**From:** Jones, Joe A [jojones@sandia.gov]  
**Sent:** Monday, February 08, 2010 4:14 PM  
**To:** Stuyvenberg, Andrew  
**Cc:** Palla, Robert; Grenier, Bernard; Ghosh, Tina  
**Subject:** Indian Point Task I Report - Deliverable  
**Attachments:** IP Task 1 Report 1 8 10.doc

**Technical Assistance in Support of the  
Indian Point Units 2 and 3 License Renewal**

**Initial Assessment - Technical Review**

Figure 1. Plot of a single weather year from the IP site 10 meter tower showing direction wind is blowing toward. (percent by direction)

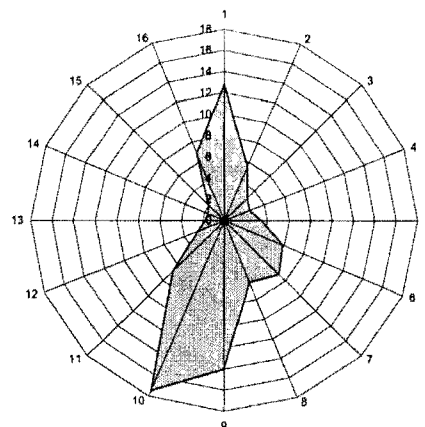
- Meteorology – In the initial submittal, Entergy used an average of 5 years of weather data. This approach is different from previous SAMA analyses

which typically use a single weather year. After major inconsistencies with regard to wind direction were identified, Entergy submitted an updated MACCS2 input file which uses a single weather year. A windrose of the MACCS2 weather input file is provided in Figure 1. As shown in the figure, the wind direction is dominant to the south toward New York City.
